# SUNNINGDALE PARISH COUNCIL

**21/02265 Crofton Lodge Devenish Road Sunningdale Ascot SL5 9PH  
Single storey side extension to the existing garage with associated landscaping.**

### 15/01965/FUL and 18/02658/COND

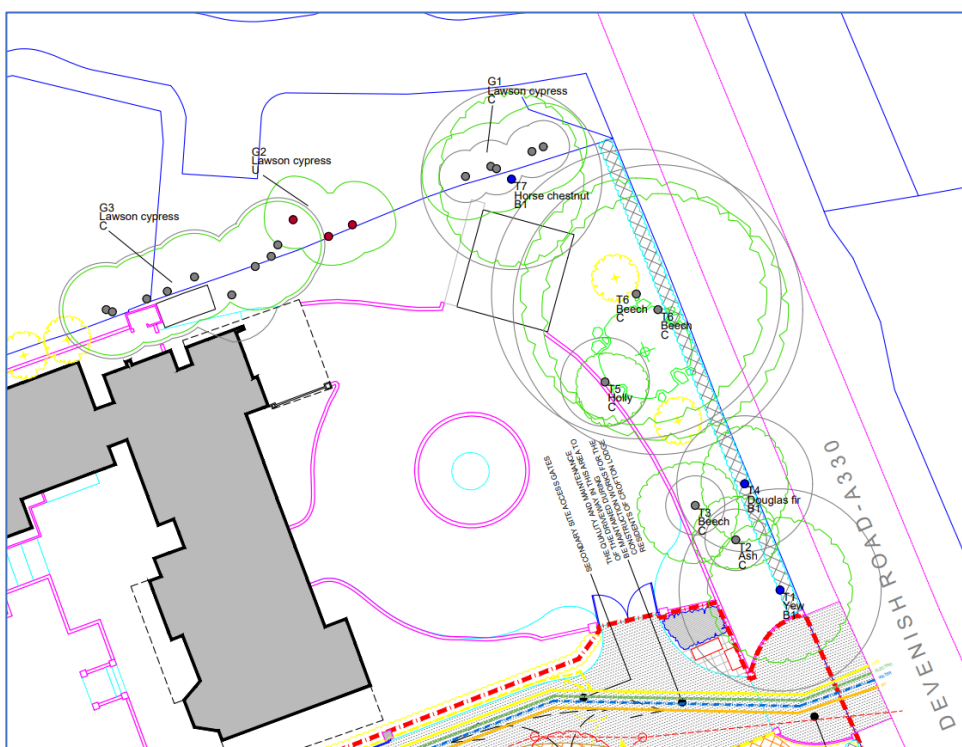
However, both 15/01965/FUL and 18/02658/COND concerned the erection of a new building on an adjacent site. Hence, there was little concern then about the trees on the Crofton Lodge site itself.

The arboricultural reports accompanying 15/01965 did not really specify individual trees for removal on the Crofton Lodge site. Section 1.3 of the Arboricultural Impact Assessment (AIA) stated: *'Trees in the low category (C - grey) have also been considered for retention, but mainly where they form part of a group of better quality trees (categories A & B) and where they do not impose a significant constraint on development'*

There was no definitive list provided of which trees were scheduled for removal. Section 2.4 of the AIA (shown below) did specify a total of 14 Category C trees and 7 category U trees for removal. This did not state whether these were on Land Adjacent to Crofton Lodge or on Crofton Lodge. Given that permission was being sought for a new building on Land Adjacent to Crofton Lodge the Parish Council would have expected all the proposed tree felling to be for the new building.

## 18/02658/CONDIT – Land Adjacent to Crofton Lodge Devenish Road Sunningdale Ascot

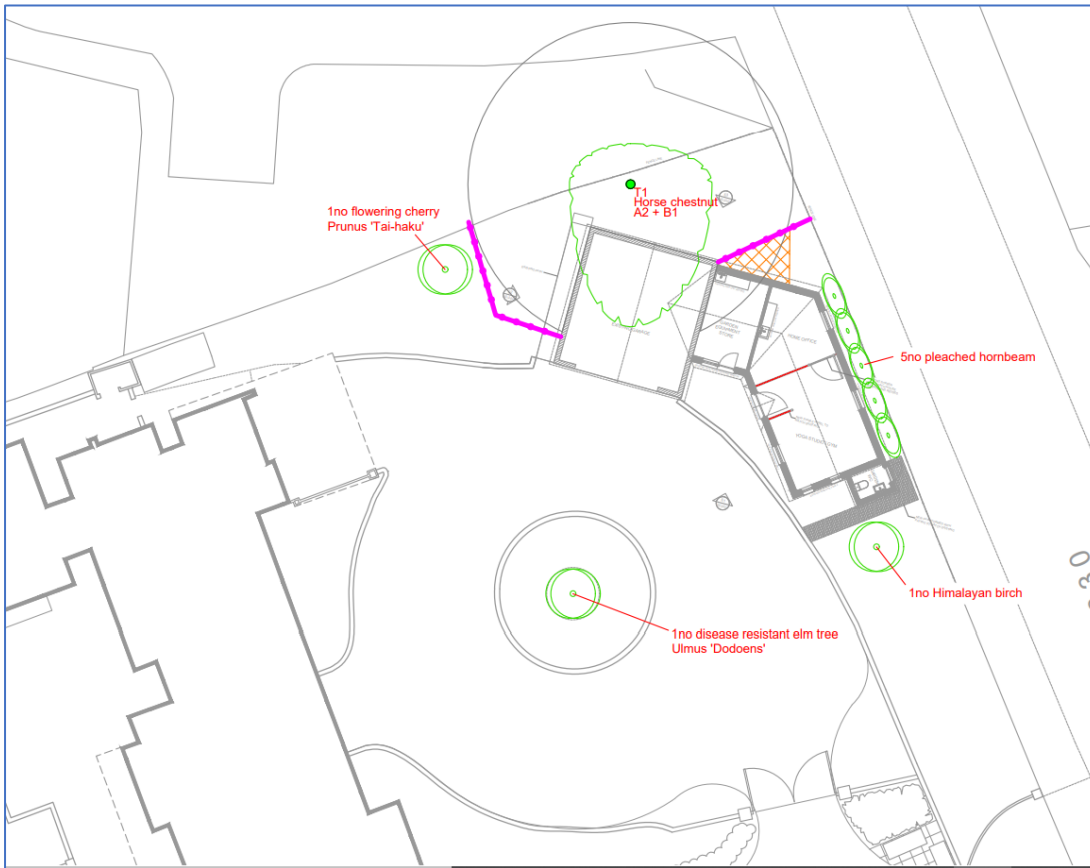
The plan left (from 18/02658) is an extract showing the trees on the border with Devenish Road. As can be seen, T6 (Cat U), T4 (Cat B), T2 (Cat C), T3 (Cat C), T5 (Cat C) are all clearly shown on the chart.

For example, T4 (Douglas Fir) shown above is a 20 metre high category B tree (Tree Management Consulting LLP report, from 15/01965). Surely this would need to be removed to allow for the construction of the new building.

Referencing the table showing trees to be removed under 15/01965 and 18/02658 it was clearly stated that **no category B trees would be removed**. The Parish Council request some explanation how the applicant can state for this application that **'the current proposal does not involve the loss of any further trees'**

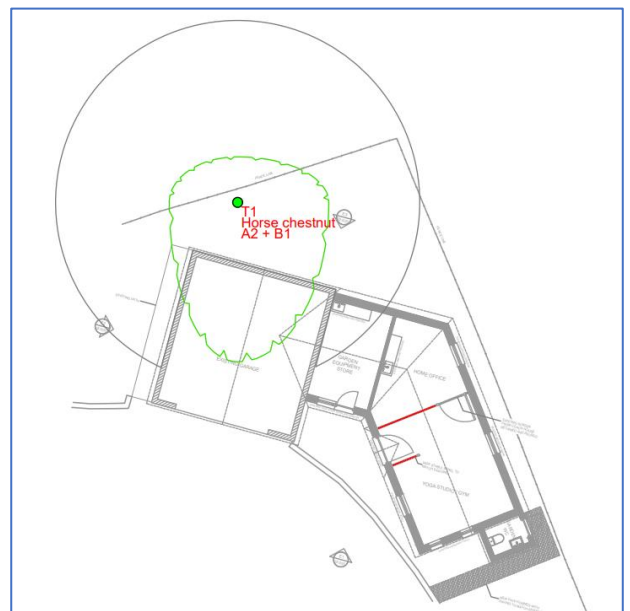
2. The Parish Council also have concerns about the trees to the North of the proposed new build. The Full Arboricultural Impact assessment chart shown below shows T1, Horse Chestnut

***'There remains the unavoidable encroaching into the RPA (of the horse chestnut tree) by 2.5% of the total RPA area.'***

The British Standard states there should be no encroachment.

We request the Tree Officer examines this chart in further detail as it would appear that excavation further into the tree RPA must surely be required in excess of the 2.5% stated to allow for the construction of the walls.

The authors states that '*only very small roots would be severed.*' However, the author does not stipulate what constitutes a small root. The Parish Council have concerns over what constitutes a small, medium, or large root and how the onsite supervision of such an operation is to be effectively managed were this application to be approved.

There also appears to be discrepancy over the species of this T1 tree.

Appendix 2 of the Merewood Arboricultural Implications Assessment report lists the trees on site. T1 in Appendix 2 is listed as an 18 metre high, Category B Lawson Cypress. But, on the plan (Full Arboricultural Impact assessment) T1 is shown as a Horse Chestnut (A2+B1). Further examination of Appendix 2 shows that there are no Horse Chestnut trees indicated on the entire site. However, as can be seen from the plan, the trunk of the Horse Chestnut (T1) is clearly shown to be within the Crofton Lodge site boundary.

Hence, if our assessment is correct, it would appear there is no information provided about this tree even though it is clearly in a public position and will be impacted by the proposed application.
